# Update Kit GRP-F100784

### Important Installation Instructions

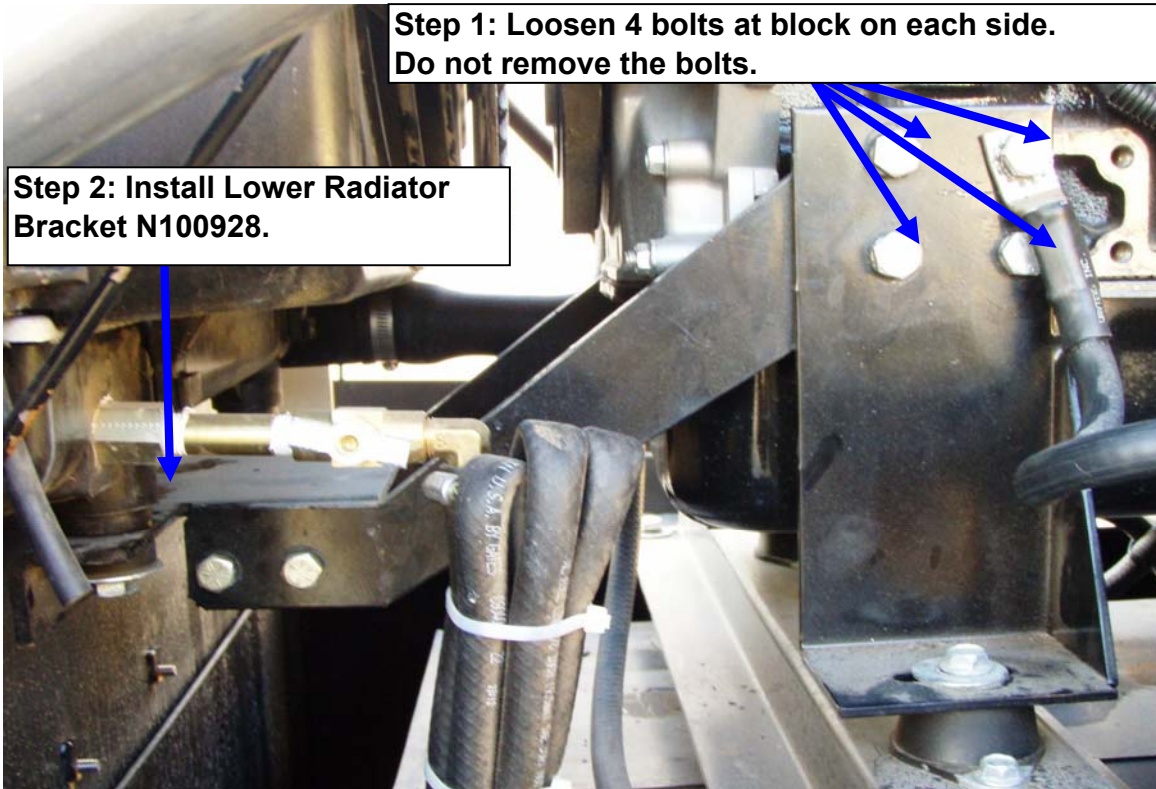
Remove original Lower Radiator Support Bracket and install new design Lower Radiator Bracket (N100928).

Loosen, but do not remove or replace the original Lower Radiator Bracket Supports Arms from each side of the engine block. Position arms in the lowest downward position.

Tighten brackets; ensure that they stay in the down position when tightening.
